# Service Bulletin

**Product Line:** Snowmobile

**Bulletin No:** 2005-1-08

**Subject:** Possible Taillight Wiring Damage

Fig. 1

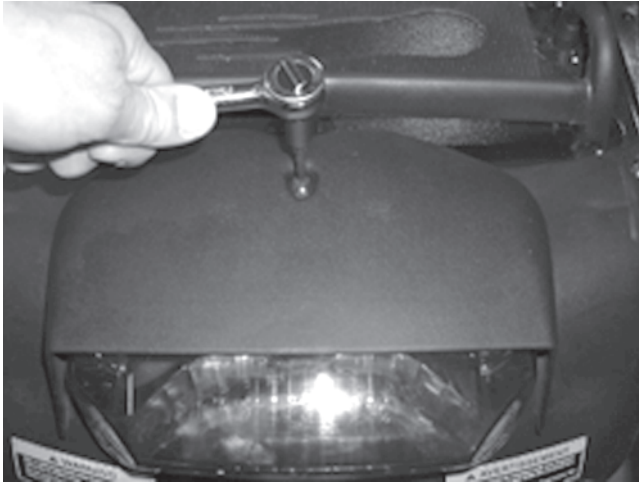
1. Remove the torx-head machine screw securing the taillight mounting housing to the tunnel/rear heat exchanger. See Fig. 1.
